2009 Annual Revision Cycle

Report on Proposals

A compilation of NFPA® Technical Committee Reports on Proposals for public review and comment

Figure 6.9.8. Attic sprinkler location.

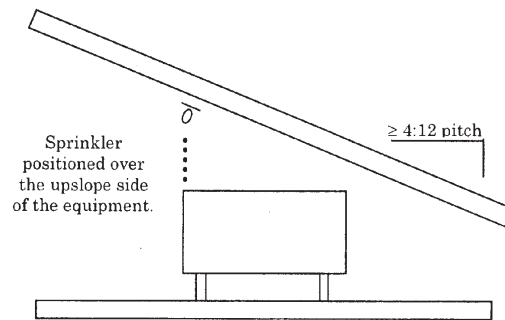
6.9.8 Attics. Sprinklers are not required in attics that do not contain fuel-fired equipment. When fuel-fired equipment is present, sprinkler protection shall be provided in accordance with the following:

- (1) At least 1 quick response intermediate temperature sprinkler shall be installed above the equipment. When the roof pitch is greater than or equal to a 4:12 pitch, the sprinkler shall be located above the upslope side of the equipment, see Figure 6.9.8
- (2) Freeze protection shall be provided in accordance with section 6.1.4.1.
- (3) The sprinkler shall have a K-factor of 5.6 and be capable of flowing at a minimum residual pressure of 7 psi.

Substantiation: The requirement for sprinkler protection in areas/rooms with "fuel fire equipment" was introduced in the last code cycle, and section 6.9.4 is new and 6.9.6 is revised in this edition of NFPA 13R. Despite all the new wording, section 6.9.4 (air conditioning equipment) directly conflicts with section 6.9.6. Additionally, the base code still fails to establish what the attic protection criteria that is required when "fuel fired equipment" is present.
